OP-SHUTTER -NEW DIE

OUTER FRAME -NEW DIE

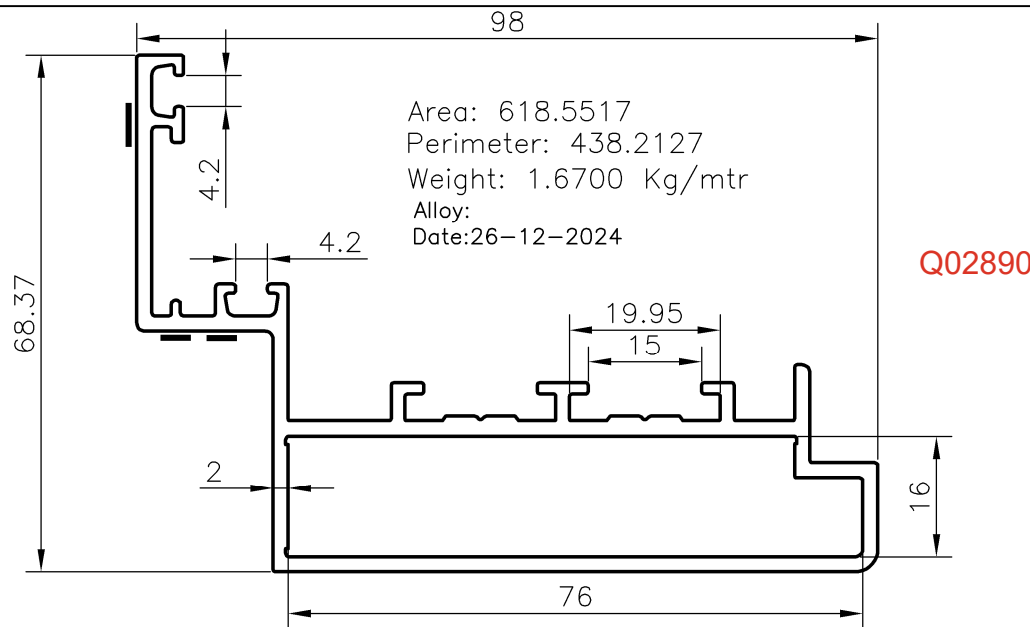
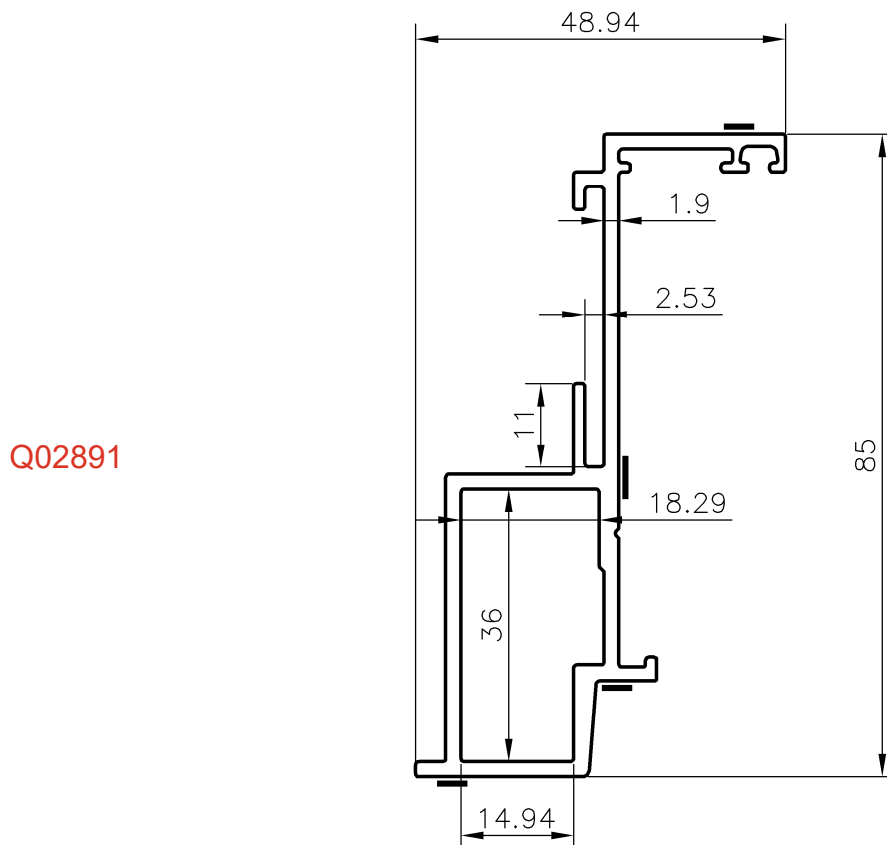
- DUE TO THICKNESS VARIATION
IMPRESSION MARK MAY APPEAR IN
THIS MARKED PORTION.
